Service-Information

Sail Auxiliary — D-7 Group No. 13 Fuel System	June 9, 1981	Bulletin No. 13003 (1005)

Subject: **Fuel System on D-7 Engine**

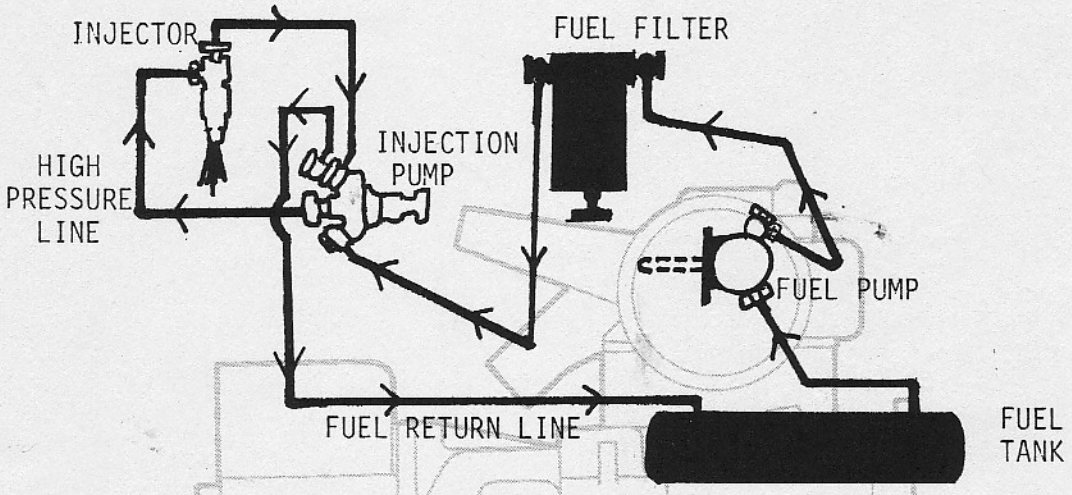
To clarify the proper sequence for the D-7 fuel routing system we have diagrammed the proper sequence below. Please check the position of **ALL** connections!

Please check all boats with the BMW D-7 engine to insure that the fuel routing on the boat conforms with the fuel routing diagram. The performance of the engine is dependent upon the proper supply of fuel through the system.

After you have changed the fuel line routing, bleed the fuel system as follows:

1. Turn the air bleed screw at the fuel filter housing out three turns.
2. Pump the fuel using the manual pump lever on the side of the fuel pump until clear fuel comes from the air bleed screw.
3. Tighten air bleed screw.
4. Start engine and check fuel connections.
